ARCHITECTURAL PUNCH LIST (EXTERIOR FAÇADE & ROOF)

Project: Webster University Interdisciplinary Science Building

Project No: CannonDesign #004561.01

Issue ID	Description	Location Detail	Location	Status	Company	Type	Date Created	Due Date
002142	Cleanup excess sealant on masonry, tool joint correctly - east projection window		Site	Open	National Glass & Glazing, Inc.	Architect Punch List	07 Aug 2017	12 Aug 2017

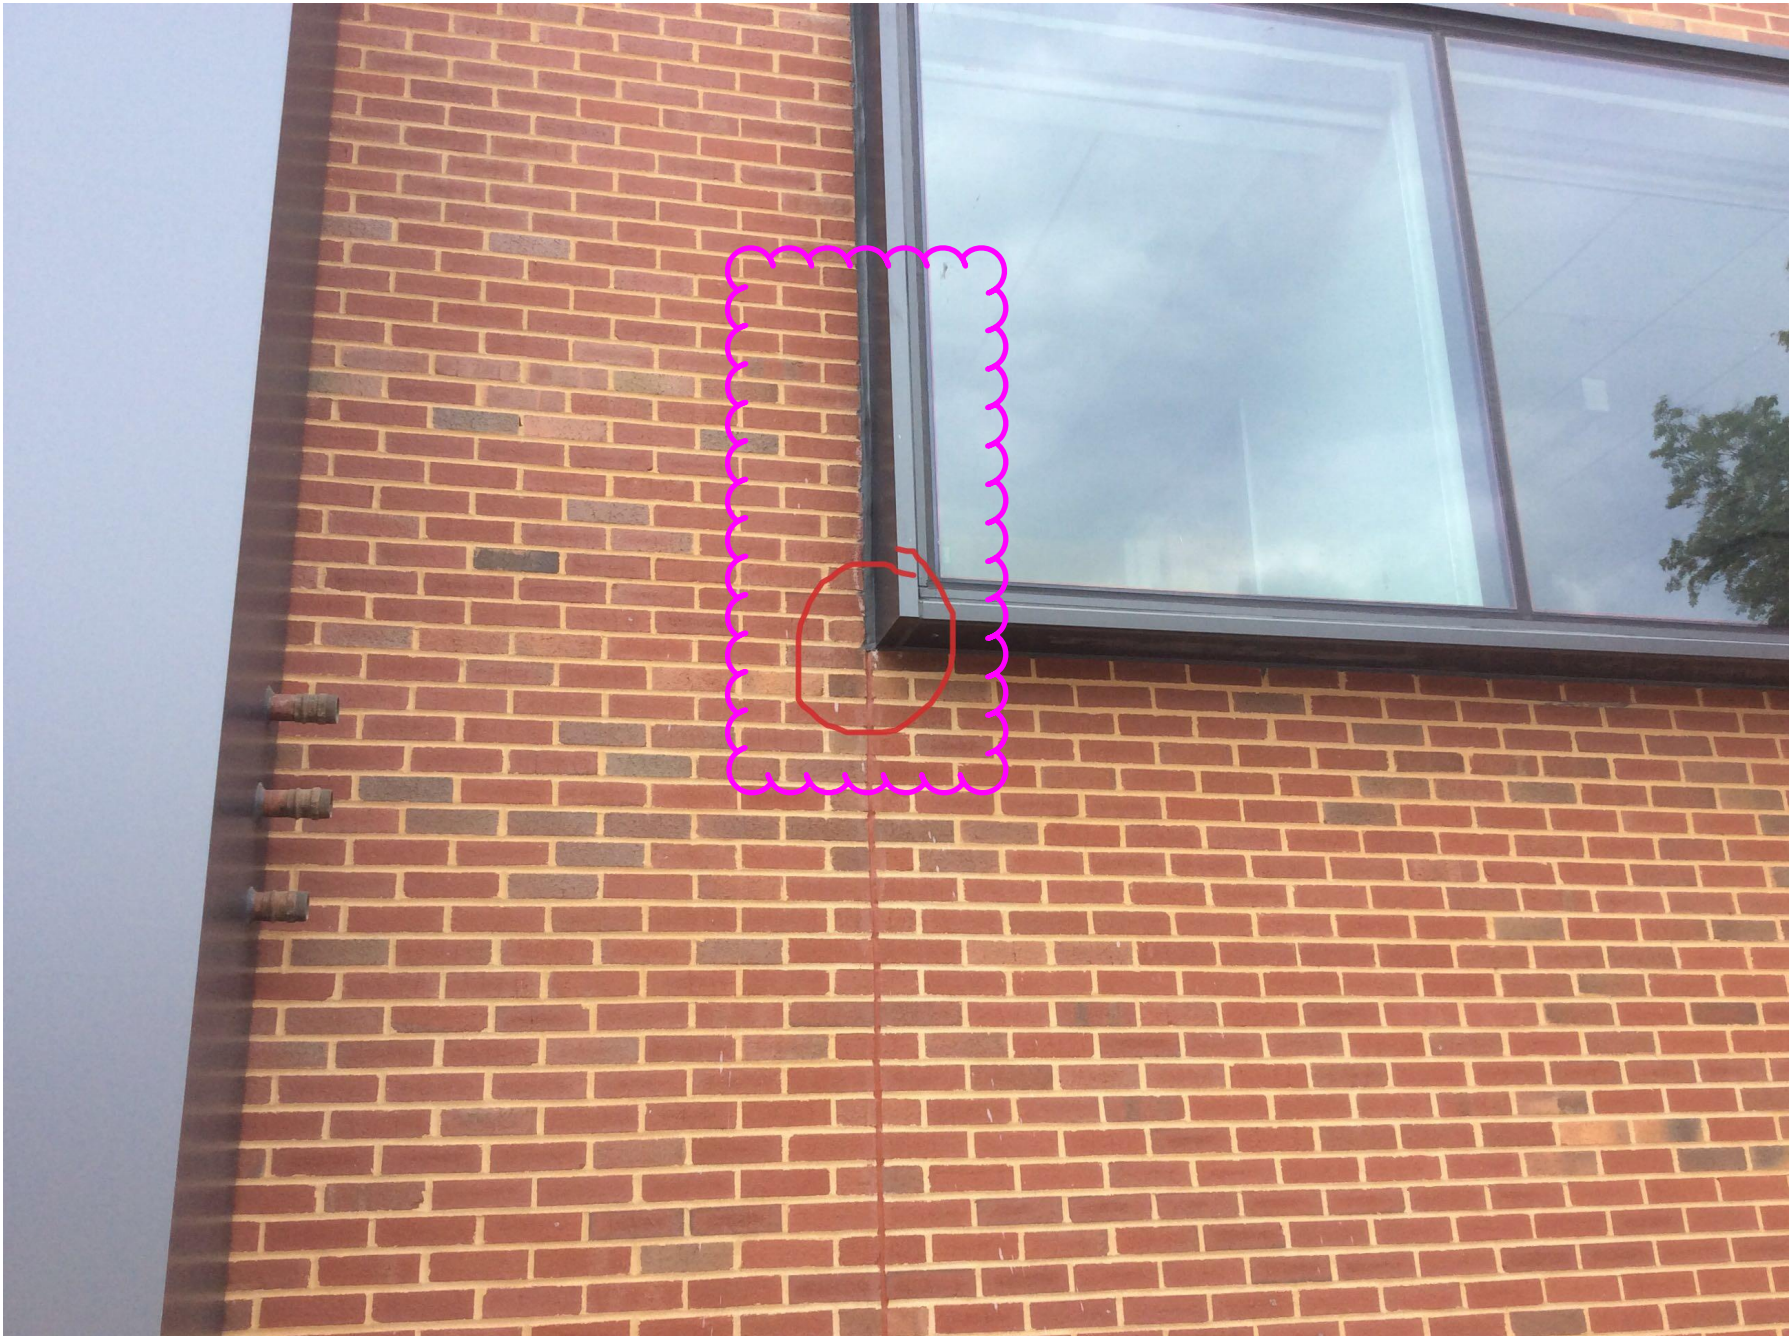
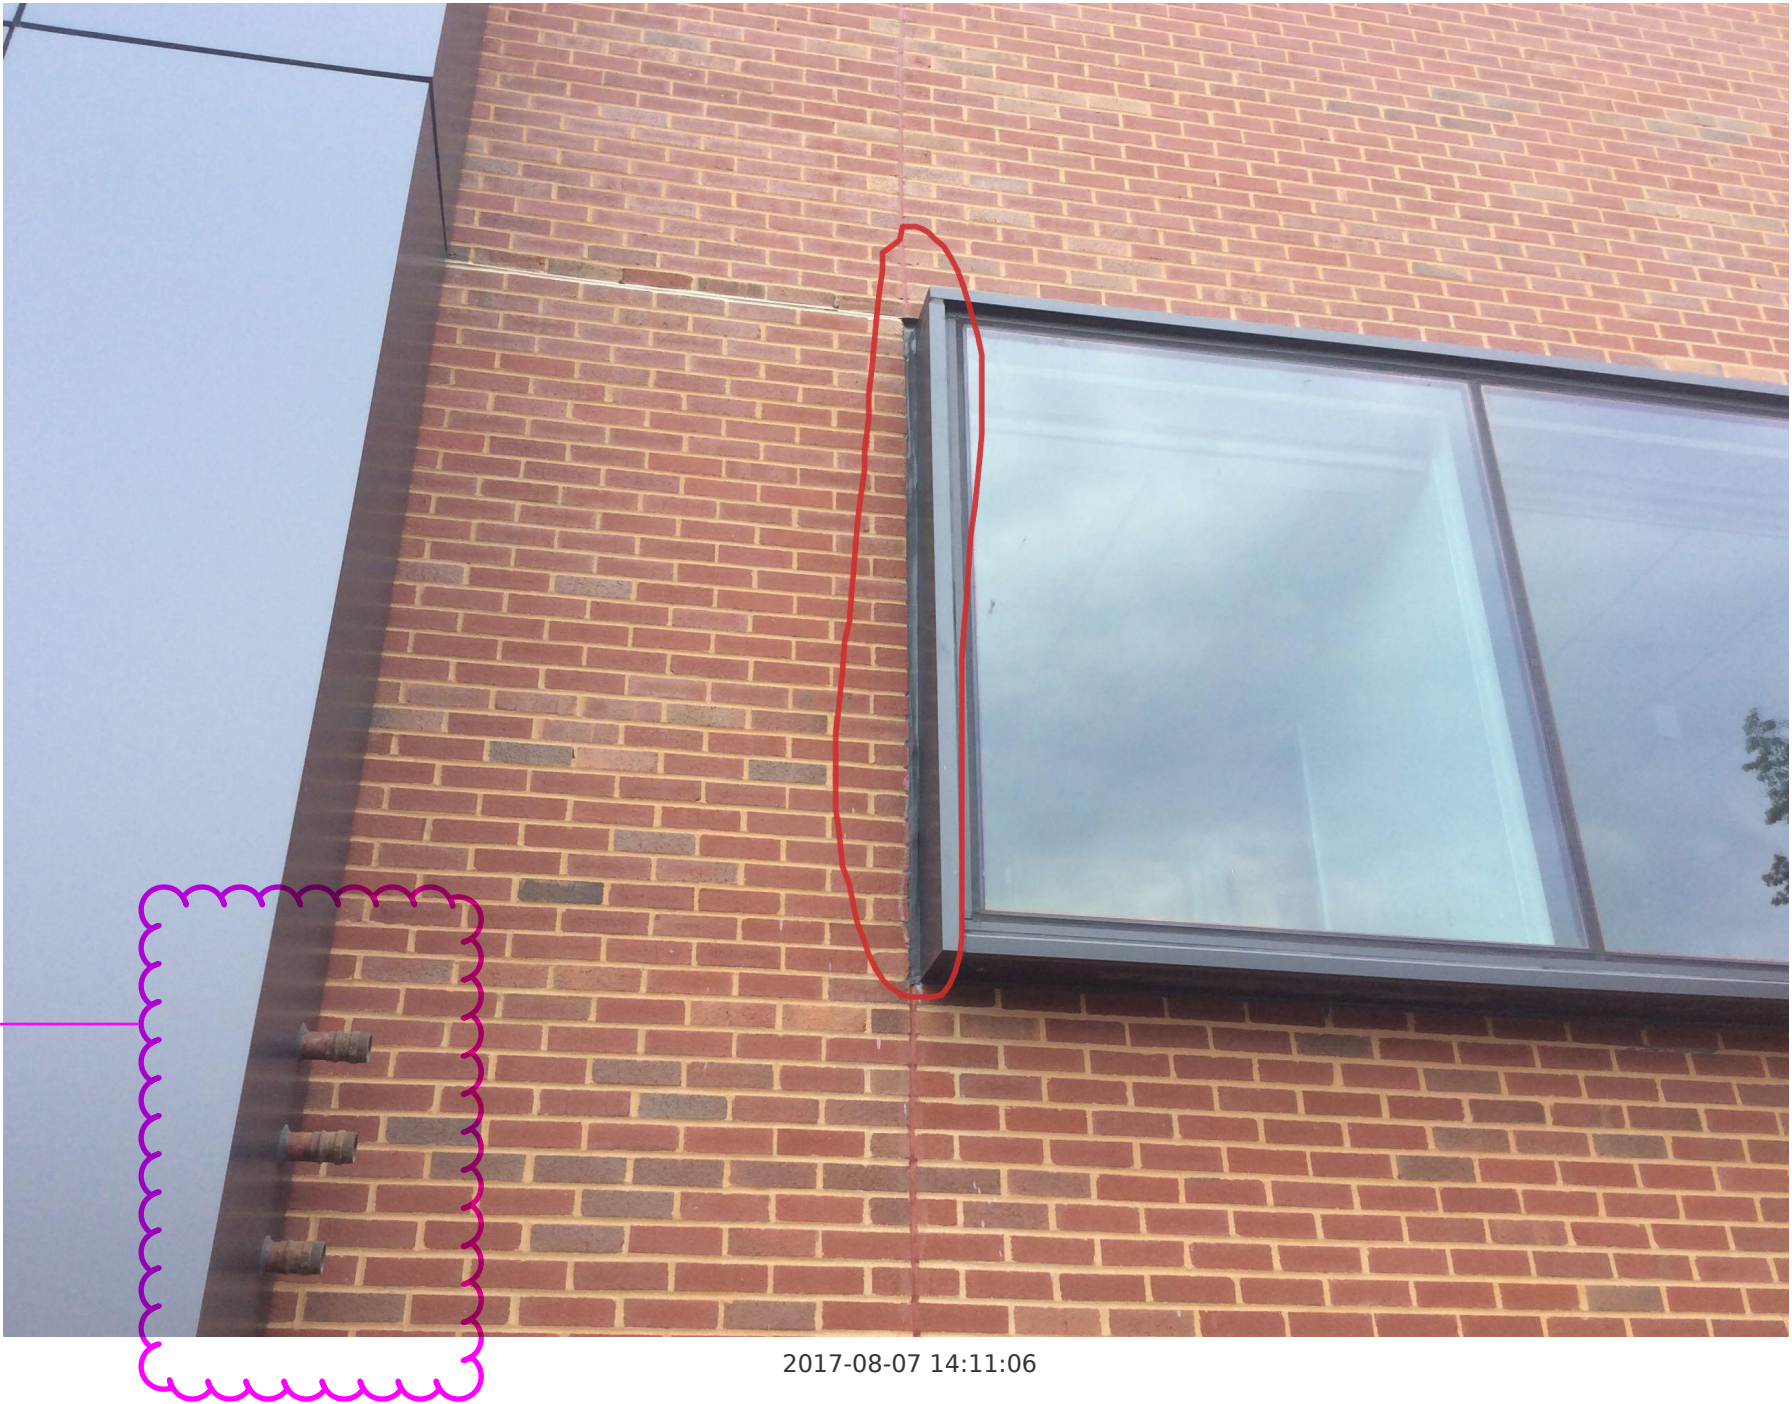
Paint pipe, color to match metal panels
